# Development Review Committee

## Staff Report

<b>Case No:</b>	20-WAIVER-0008
<b>Project Name:</b>	Dollar General Store
<b>Location:</b>	7701 Smyrna Parkway
<b>Owner(s):</b>	Kennie and Patricia Combs
<b>Applicant:</b>	SC Development LLC
<b>Jurisdiction:</b>	Louisville Metro
<b>Council District:</b>	23-James Peden
<b>Case Manager:</b>	Joel Dock, AICP, Planner II

- **Waiver** of Land Development Code, section 5.6.1.C.1 to not provide clear windows and doors on at least 50% of the wall surfaces at street-level

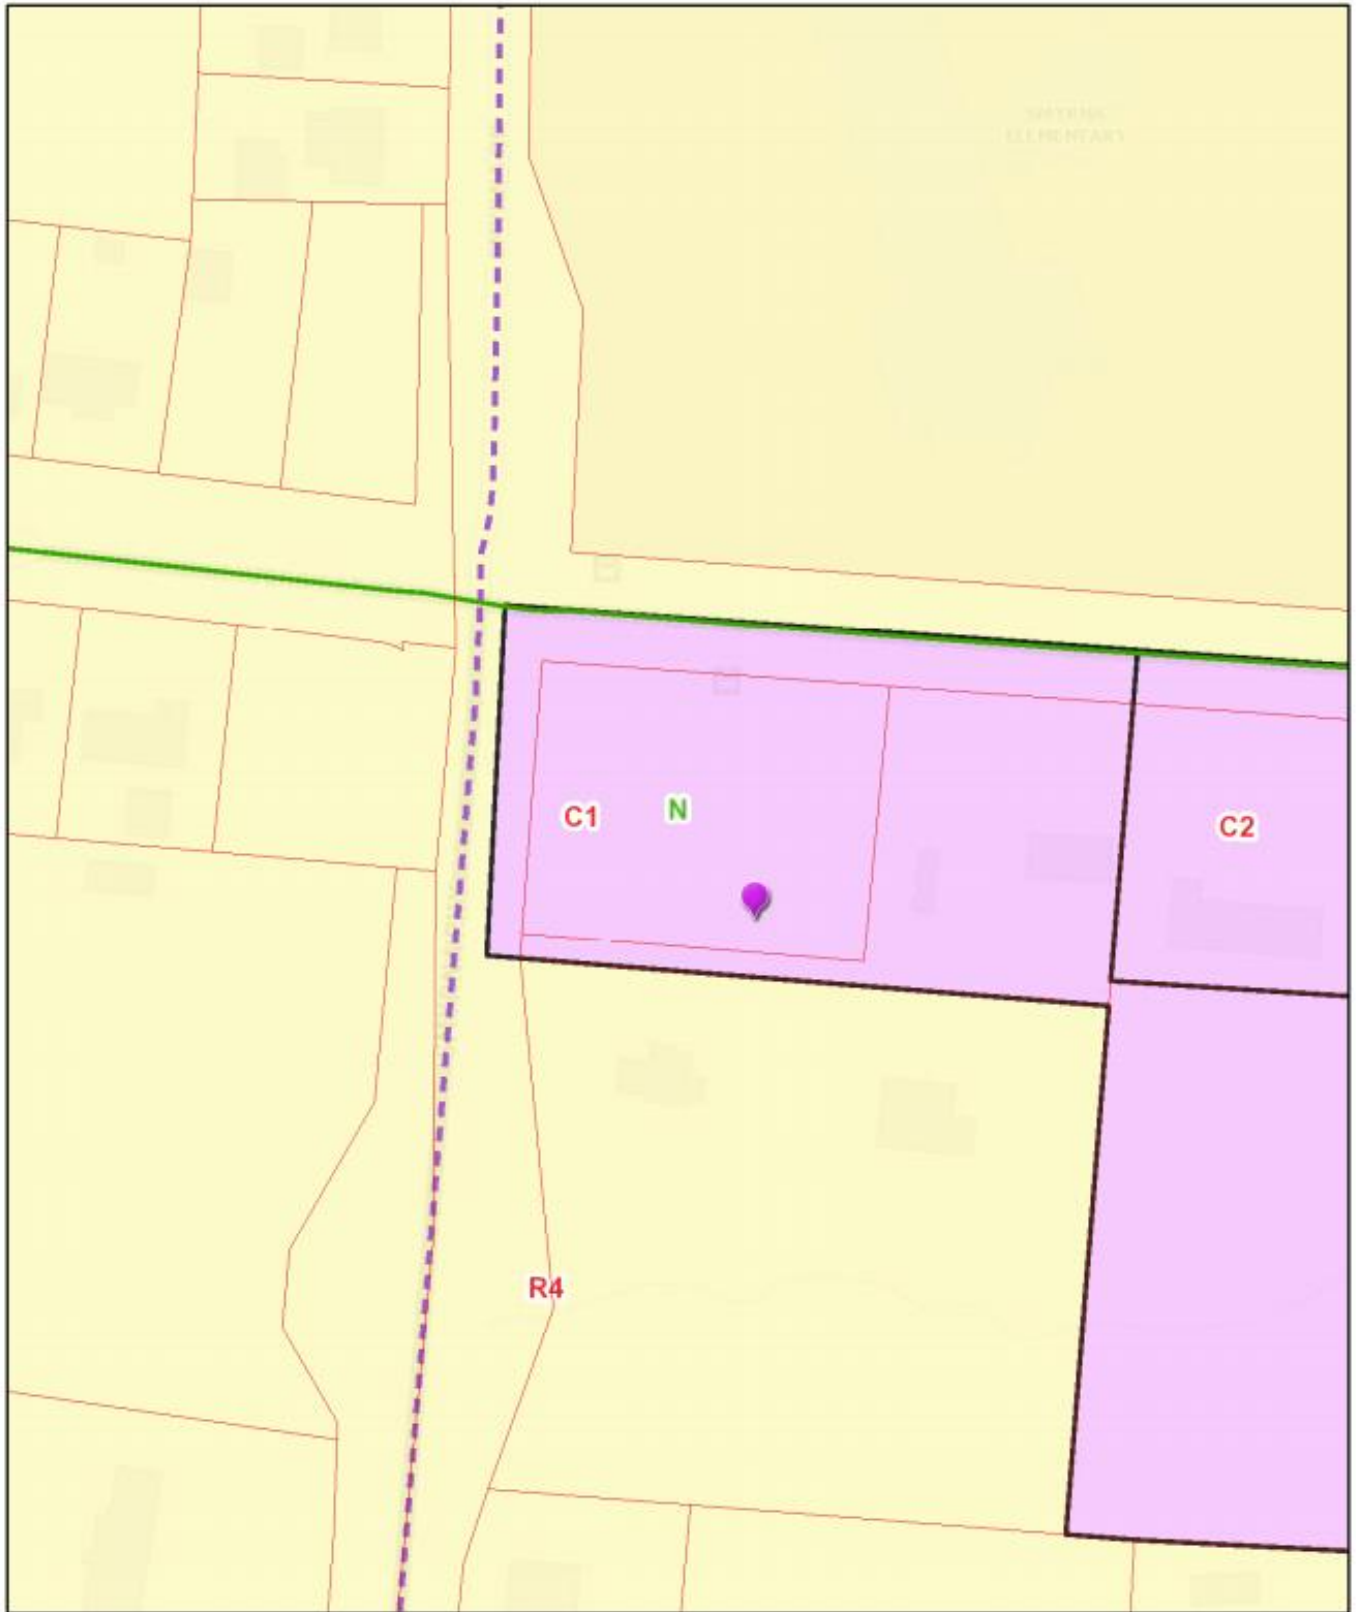
STAFF: The waiver will not adversely affect adjacent property owners as the proposed windows will not detract from the existing character of these properties or cause a nuisance through the design upon these properties. The user to the east is an auto garage, across Outer Loop an auditorium or gymnasium for an elementary school is nearest to the roadway which does not provide clear windows, and two other adjacent properties are vacant. The property owner to the rear/south is not impacted by the facades in question.

projects. The character of Outer Loop in the immediate area consists of users in multi-tenant buildings or stand-alone services with parking lots between structures and the roadway. Immediately adjacent to the proposal are two auto service garages that provide bays opening to the roadway. A retail strip center with clear windows for tenants is present roughly ¼ mile east of the site. Based on a review using Google Streetview many of the clear windows are occupied by advertisements interrupting views into the business. The proposal is consistent with the design of Dollar General Stores located in throughout suburban areas of Louisville Metro. The materials proposed are consistent with the desired pattern of development as multiple building materials are proposed and the façade facing outer Loop contains a wall plane projection at the entrance, as well as clear windows in the area of the entrance. The faux windows provide architectural interest as they mimic a “real” window and provide awnings above. For these reasons, the requested waiver appears to be compliant with Plan 2040.

STAFF: The full extent of the waiver of the regulation is not the minimum necessary to afford relief to the applicant as display windows are specifically authorized and the internal layout can be revised to relocated restrooms and storage to walls not containing windows as two facades are not required to comply with the regulation.

The requested waiver appears to be adequately justified based on the standard of review contained in the staff analysis.

STAFF: The strict application of the provisions of the regulation would deprive the applicant of the reasonable use of the land or would create an unnecessary hardship on the applicant as the proposal does not negatively affect adjacent property owners and maintains consistency with Plan 2040.
